# **Authorized Field Change**

**AFC G-06905**

**SUBJECT: Warning labels on air intake and air cleaner housing may be missing or not visible on certain CE, RE, and PT bus models built at the Conway, Arkansas Bus Assembly Plant before 11/28/2005.**

**APPLIES TO: Various CE, RE, PT (sold to Bluebird) bus models built before 11/28/2005.**

**Placement for: CE - Model PB105 & PT - Model PB015 with Bluebird Body**

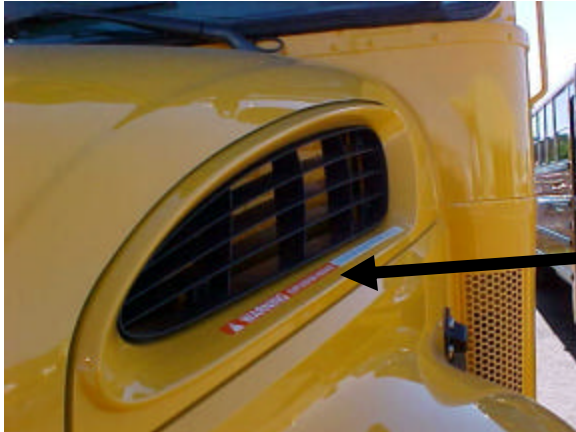
*Apply this label if your CE bus has an I6 engine with a grid heater (feature code 12WSZ) installed.*

Decal should be installed at the location indicated by the arrow.

**Placement for: RE – Models PB305, RE300, GD395, GC395**

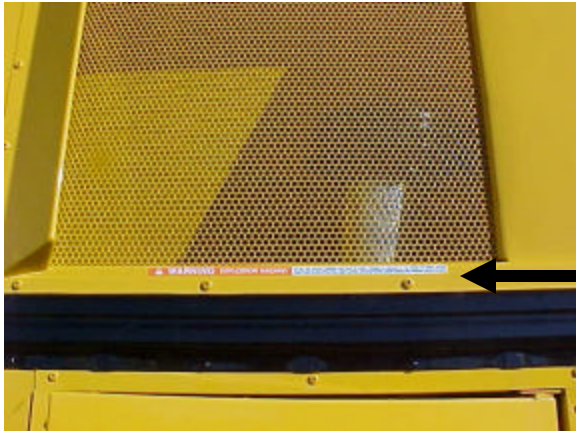
*Apply these labels if your RE bus has an I6 engine with a grid heater (feature code 12WSZ) installed or a V8 engine.*

Decal should be installed in this area just below the air intake screen. The air intake for the I6 is on the left side (driver's side) and on the right side with V8.

Existing label on RE with I6 may be upside down or facing down. Apply new label (shown below) on end of air cleaner so that it is always visible.
